PLAN COMMISSION STAFF REPORT

Agenda Item: PC Docket No. 23-010

Application: **Zoning Amendment – Planned Unit Development Amendment**

Summary: Maple Leaf Crossing LLC requesting approval of an amendment to the Maple Leaf Crossing Planned Unit Development to add parking spaces and modify Lots 2-7 and Outlots A and B.

*Parking

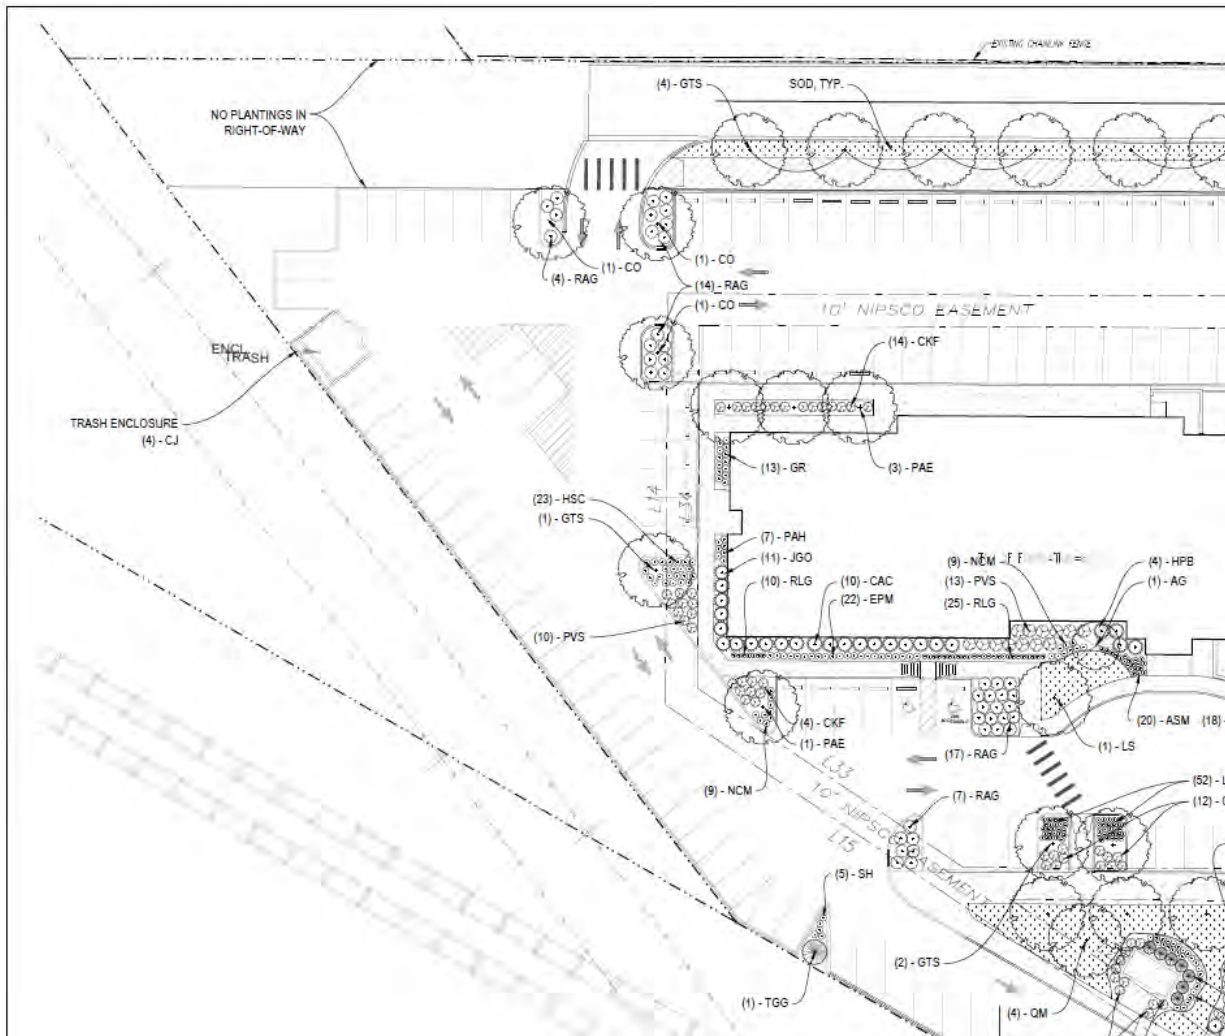
The original 358 parking spaces within the Maple Leaf Crossing PUD were intended to be shared among all users. At the time of approval of the PUD, a parking study was submitted which calculated that 350 total shared spaces were required for the development.

A revised study was provided in connection with the PUD amendment to permit the cigar bar. The study indicated that 52 spaces (12 additional) would be required for the proposed cigar bar and

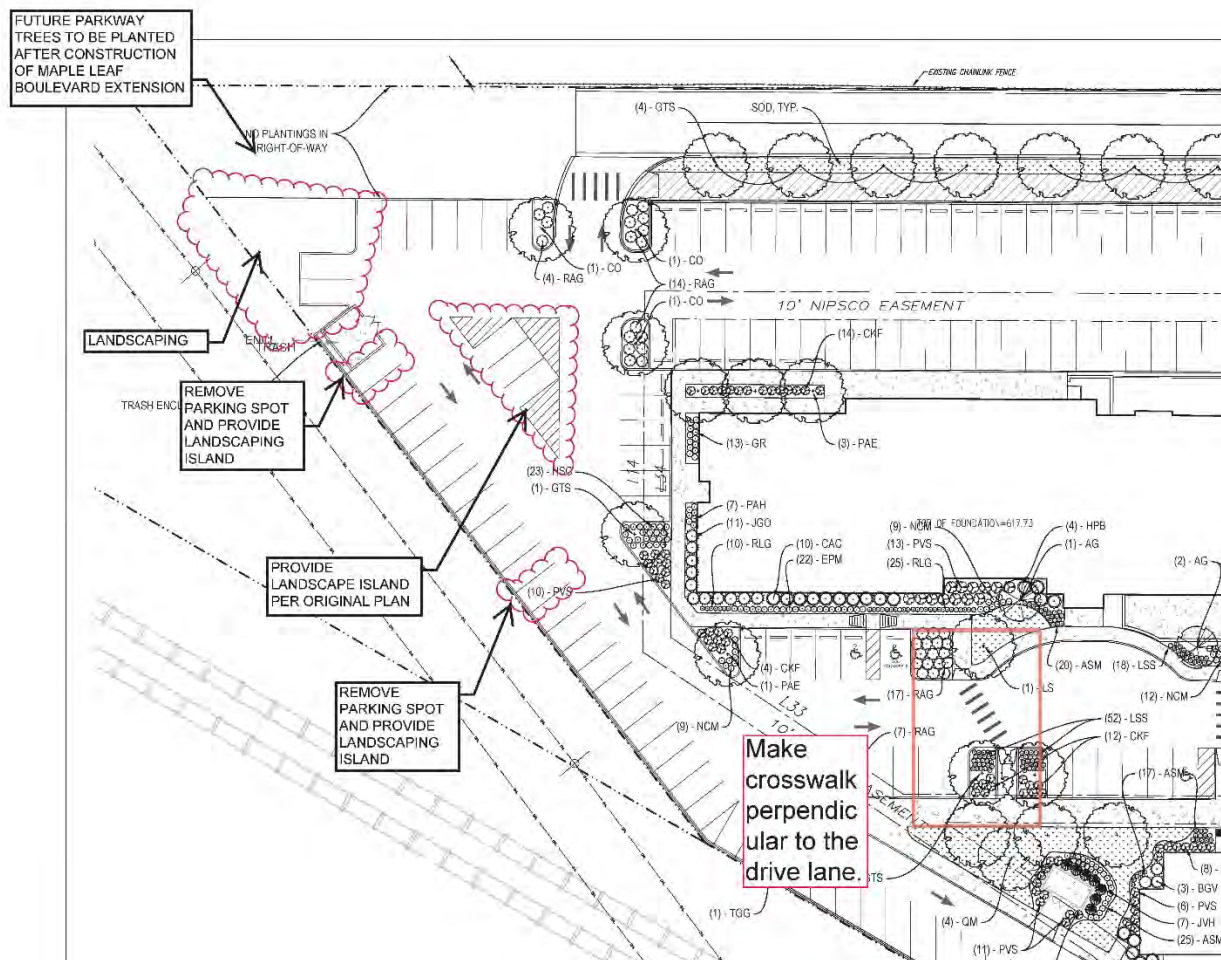
However, staff is concerned with the increase in hardscape and the decrease in landscaped areas in the petitioner's proposed plans. Since the petitioner has not provided new evidence or data that additional parking spaces are needed for the approved uses at Maple Leaf Crossing, the need to replace landscaping with parking spaces is not clear. According to the Munster Zoning Ordinance, landscaping for parking lots should follow Section 26-6.405.O.1.h.vii.l. Key parts of this section of the code include the following:

- 1) Parking Areas and Parking Lots shall contain at least one landscape island for every ten (10) parking spaces. Parking Lots with more than one landscape island shall have such islands distributed throughout the Parking Lot.

5) Rows of parking fronting on drive aisles including alleys shall be provided with a minimum five feet (5') (excluding curbs) landscaped buffer.

7) For every 2,000 square feet of Parking Area or Parking Lot, at least one Tree shall be installed or preserved within the Parking Area or Parking Lot except to the extent that Trees outside of the Lot containing the Parking Area or Parking Lot are allowed to satisfy this requirement as set forth below.

With these standards in mind, staff has proposed the following modifications to the landscape plan in order to be closer to compliance with the Zoning Ordinance:

- A commitment to plant future parkway trees after construction of the Maple Leaf Boulevard Extension in the right-of-way labeled "No Plantings in Right-of-Way."
- The removal of 3 proposed parking spaces to be replaced with landscaping in the far northwest corner of the site.
- The removal of 1 parking space southeast of the trash enclosure to be replaced with a landscape island in the northwest corner of the site.
- The removal of 3 parking spaces just west of the NIPSCO easement in the northwest corner of the site to be replaced with a landscape island per approved development plan (see Section 26-6.405.O.1.h.vii.I.5).
- The removal of 1 parking space west of the NIPSCO easement in the northwest corner of the site to be replaced with a landscape island (see Section 26-6.405.O.1.h.vii.I.1).

With these modifications, the proposed parking of the site would be decreased by eight (8) spaces, for a total of 377 parking spaces, which is still a 7.1% increase in parking from the approved development plan per Ordinance 1879. See image on next page for more details.

Staff also recommends the crosswalk in Outlot A between Lot 2 (Hyatt) and Lot 7 (cigar bar and restaurant) be redesigned to be perpendicular with the drive lane. Crosswalks that are perpendicular to cross the street (or drive lane in this case) are shorter and help to move pedestrians through a street or drive lane more quickly. See image on next page for more details.
